Siemens Technical Bulletin STAB16-0100

Problem with PCaTS Firmware Iss1 for Green Man Periods >80s

Product: PCaTS

Figure1 – IC7 Label with Firmware Revision Details

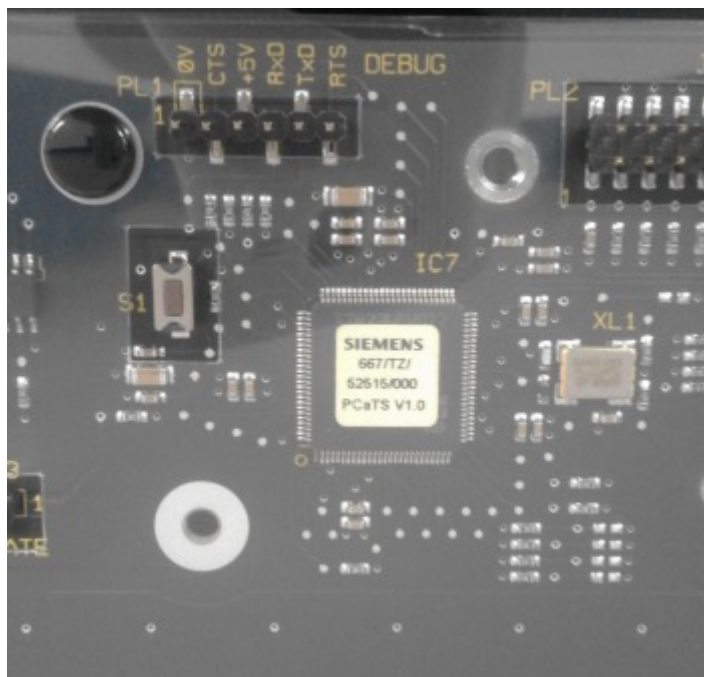
The Firmware revision is detailed on the PCaTS door assembly by a label on IC7 (as shown in Fig1).

It is therefore recommended that, should you have sites with long green man periods, the PCaTS door assembly should be returned to Poole for upgrade to Issue2 Firmware. Also all spares not installed by the end of June 16, should also be returned to Poole for upgrade to latest firmware.
